client	Mr & Mrs D. NAPIER
project	Proposed Two Storey Extension to the Rear and Side of 32 Mitford Road, South Shields. Tyne & Wear. NE34 0EQ
drawing	PROPOSED ELEVATIONS
scale 1:50	date July 2019 drawing No. 04-07-19

Proposed Front Elevation (north/east)

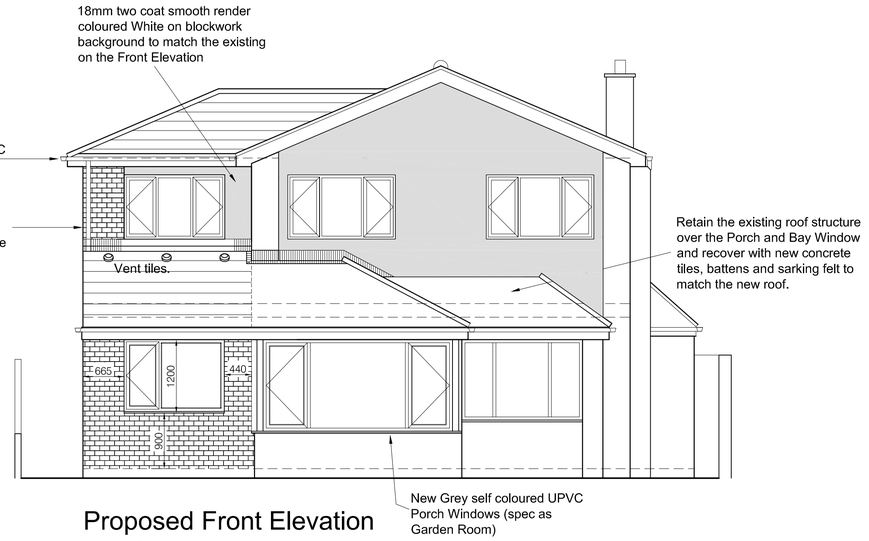
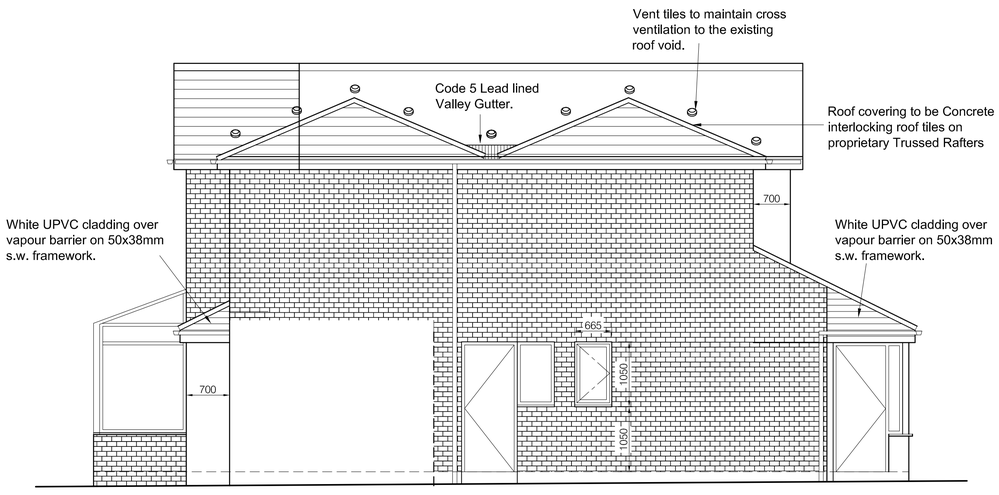
1. Brick piers to Front Elevation Left side increased from 553 to 665mm, windows reduced inside by 112mm.
2. Mechanical Extract Note Added.
3. Foundation note added.

Proposed Rear Elevation (south/west)

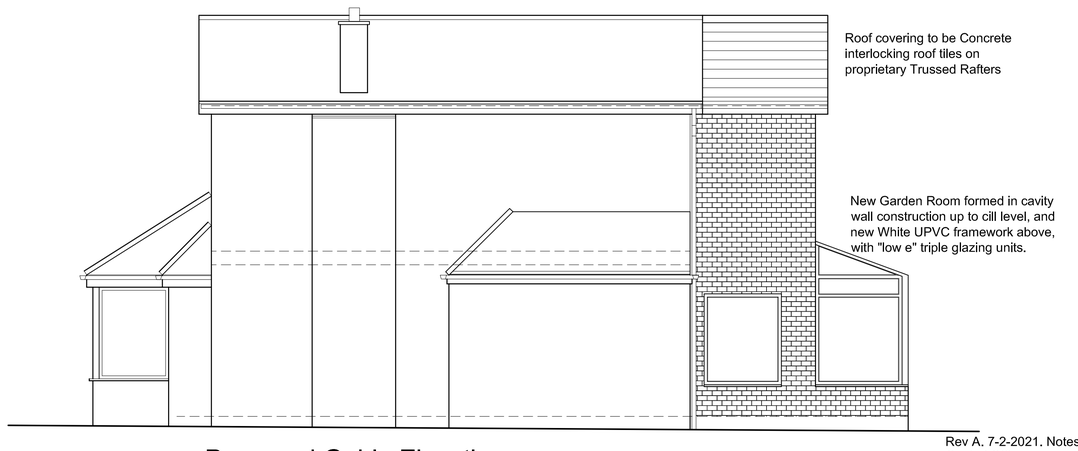
Rev B. 06-05-2021. Rear of Side Extension stepped back as requested by the Planning Officer.
